Access Compliance Report Public Rights-of-Way (Curb Ramps)

Intersection ID: 27211 Main Street: FORBES_DR Cross Street: PROVIDENCE_RD Location: SW

ADA ID: 69A49823FD22 Ramp Type: BlendTrans2 Initial Pass/Fail: Fail Overall Compliance: No Severity Score: 12.5

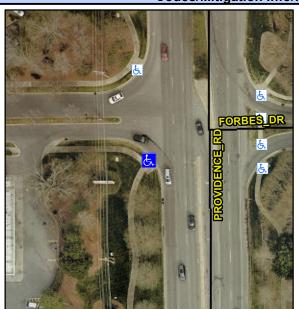
Not Found, R304.5.3

Remove & Replace Curb Ramp With Two New Directional Ramps or Equivalent.
